HDC-2022-00030

Address: 526 W. Liberty Street

District: Old Fairgrounds Historic District

Proposal: Legalize porch reconstruction (Violation Correction)

Law Street elevation of 526 Liberty Street after work was completed.
(Staff)

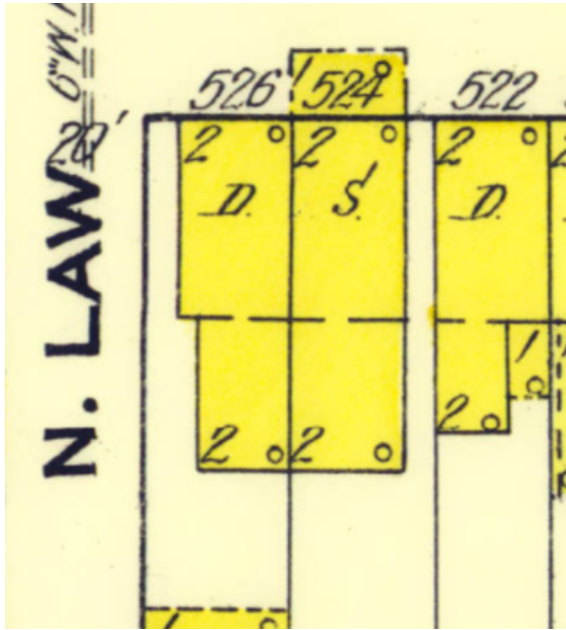
The installation of the wood posts and railings is appropriate in material. However, the dimensional lumber posts are not consistent with Guideline 3.7.8. An option to mitigate the existing dimensional lumber is to conceal the exposed steel

brackets at the base of each post with simple trim. All wood members should be painted. While the posts, balusters, and railings are utilitarian and lack any decorative features, no evidence exists to provide guidance on a more appropriate restoration.

DH stated the design as built does not meet the guidelines and questioned the railing height meeting code.

AJ stated the design as built does not meet the guidelines, nor is it something the HARB would approve in ordinary circumstances and suggested the HARB work with the applicant to find a solution that could be approved as appropriate.

DH suggested the potential for adding trim to the top and bottom rails that would be more in keeping with the other profiles in the neighborhood.

GL suggested removing the vertical balusters, adding a top and bottom rail with a profile more in keeping with the historic profiles found elsewhere in the district.

AJ requested additional trim molding be added for detail.

DH requested the posts be chamfered on all four vertical edges.

Approval, provided the wood posts, balusters, and railings are painted and wood trim is added at the base of each post, pursuant to Chapter 3, Section 3.7 Porches and Steps.

1. The wood posts, balusters, and railings are to be painted.
2. Wood trim is to be added to the base and top of each post.
3. Posts are to be chamfered.
4. Railings are to be reoriented to ensure balusters do not overlap the face of the rails.
